## **Appendix 2 – Consultation feedback**

**Consideration of matters raised during consultation on earthquake processing and disposal activities at the Burwood Resource Recovery Park and Burwood Landfill**

**Figure 2**

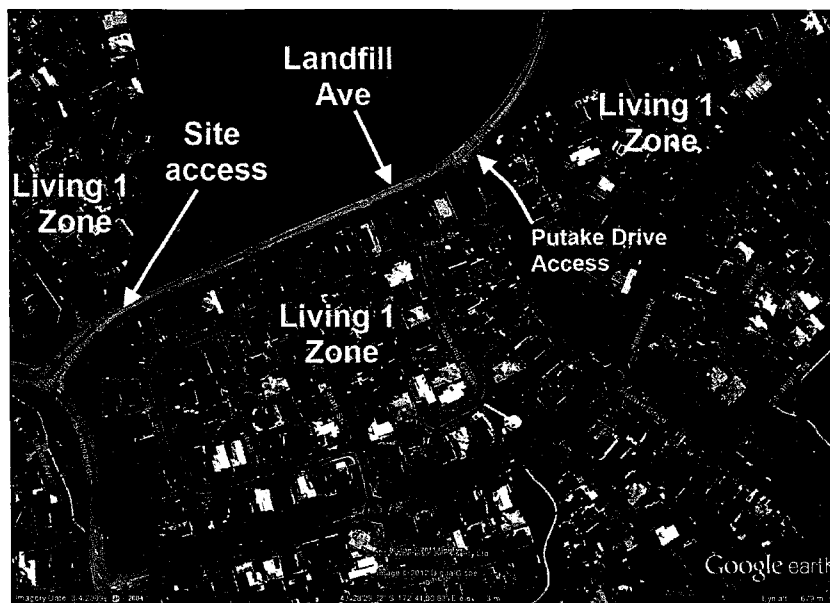
- 5.3. The close relationship of the Living 1 zone residential area to the site accesses and the waste transport route on Landfill Avenue are shown in Figure 2 below.

- 5.10. My main reason of concern that a lower fence would not provide sufficient noise attenuation is that the number of trucks used by Mr Smith to model the contours is not representative of the busiest night-time hour. Referring to section 4.4 of the report, the figure of 20 tanker movements per hour during night-time is associated only with Site P; however haulage trucks from the BRRP will also use the site access and road between 6 am and 7 am, which is a noise-sensitive time of the day. I also note that the number of trucks during daytime (320) is inconsistent with the number of truck movements in the AEEs (refer paragraph 5.1 above) which indicate there would be 940 truck movements involving 470 trucks (i.e. 740 movements for Site F, and 200 for the BRRP during daytime).

- 5.12. To provide certainty, I have recommended a condition of consent requiring that:
